AGENDA
VENETA PLANNING COMMISSION
TUESDAY – MARCH 1, 2016 – 6:30 P.M.
Veneta Administrative Center, 88184 8th Street, Veneta, Oregon

**VENETA PLANNING COMMISSION'S
STAFF REPORT**

Yurtel, Bed & Breakfast – Track 2 Site Plan Review, City File #SR-5-15 – Track 2

**Yurtel Bed and Breakfast, Track 2 Site Plan Review,
City File #SR-5-15 – Track 2,
Assessor’s Map and Tax Lot No. 17-05-31-32-02300**

Designed by MASHORT <i>M.S.</i>	Checked by _____	Approved by - date _____	Filename YURTEL-GRD	Date 10/29/2015	Scale 1:20'
MR. & MRS. JIM, HADDOCK 87991 TERRITORIAL HWY VENETA, OREGON <i>J.H.</i>			GRADE-PLAN		
			73U92015	Edition -	Sheet A-5

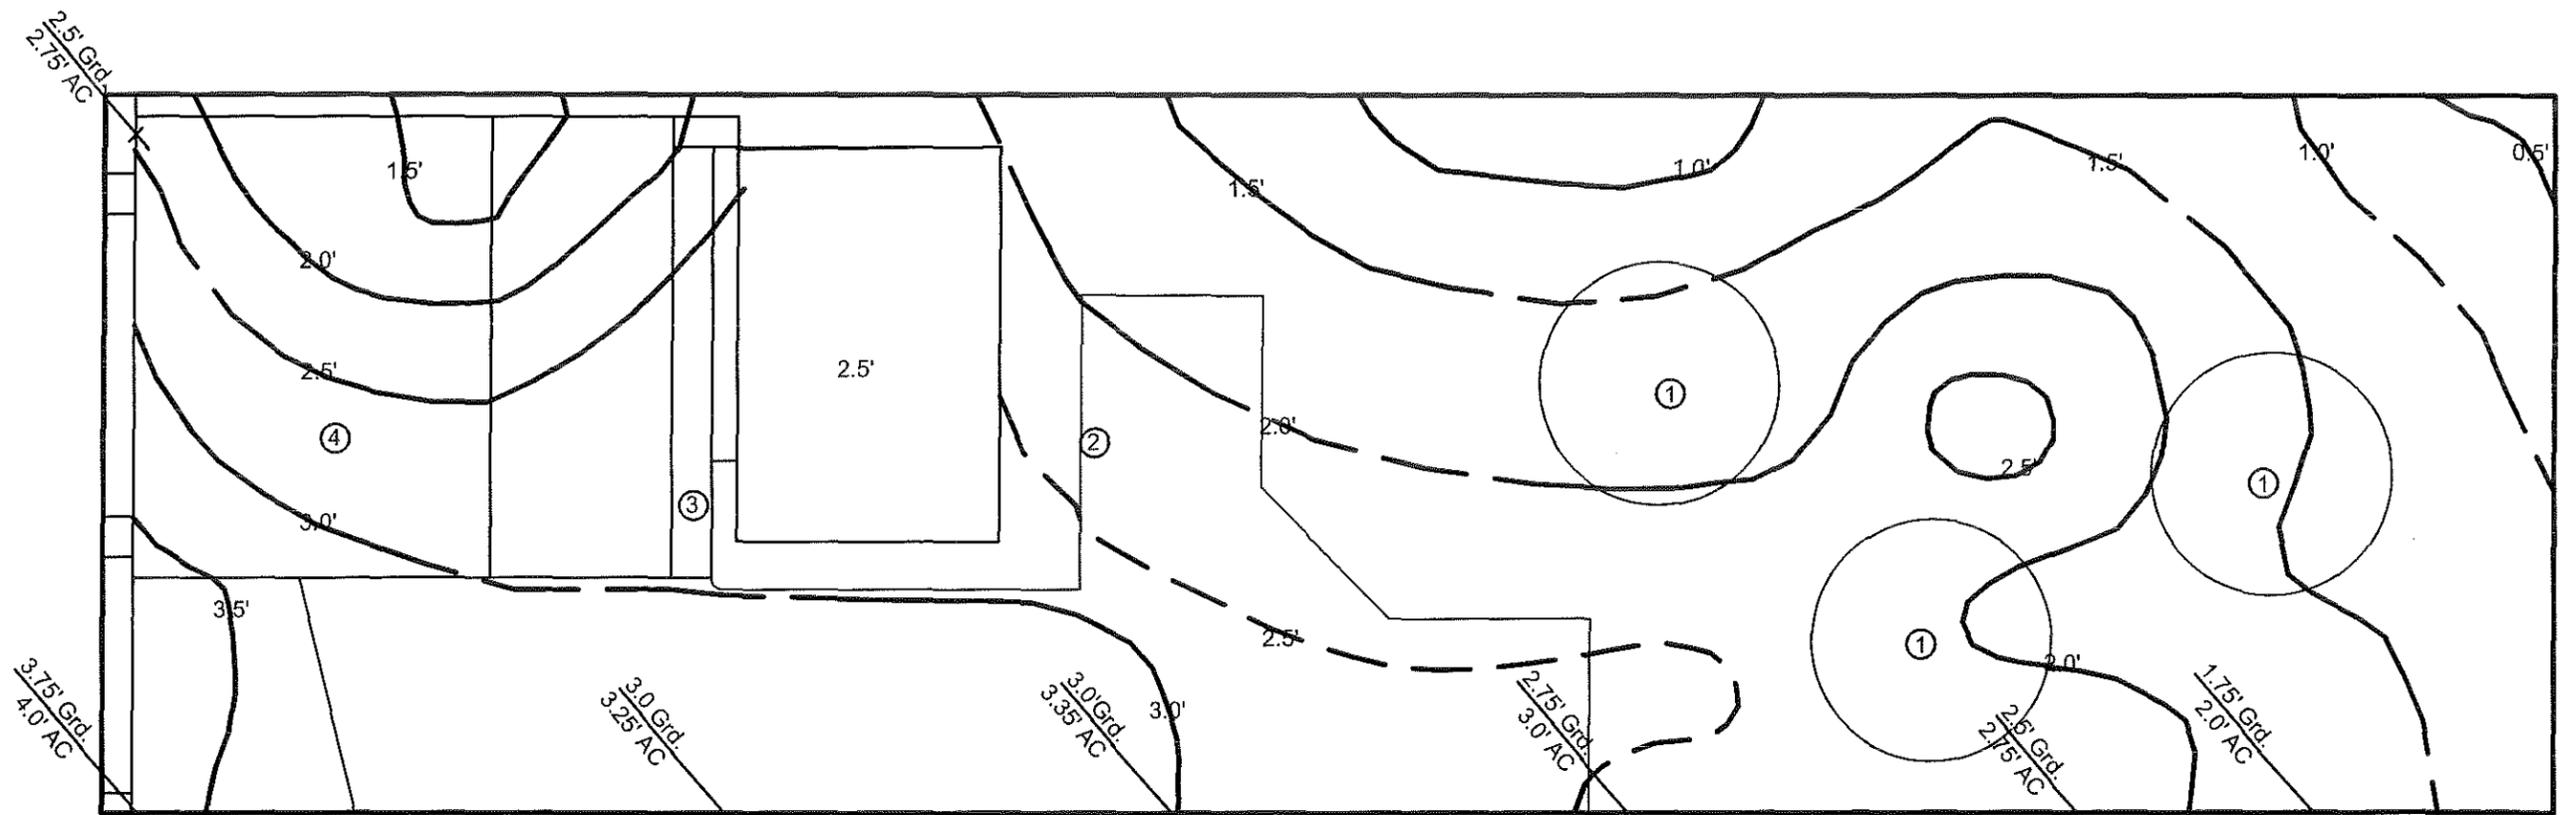
The proposal is consistent with this standard. A Grading Plan (Sheet A-5) has been submitted. The City Engineer has commented that the proposed yurt structures, sidewalk and a parking space are proposed to be constructed with minimal grading disturbance. New impervious surface improvements are less than the 1,000 square feet area threshold to require stormwater detention and treatment.
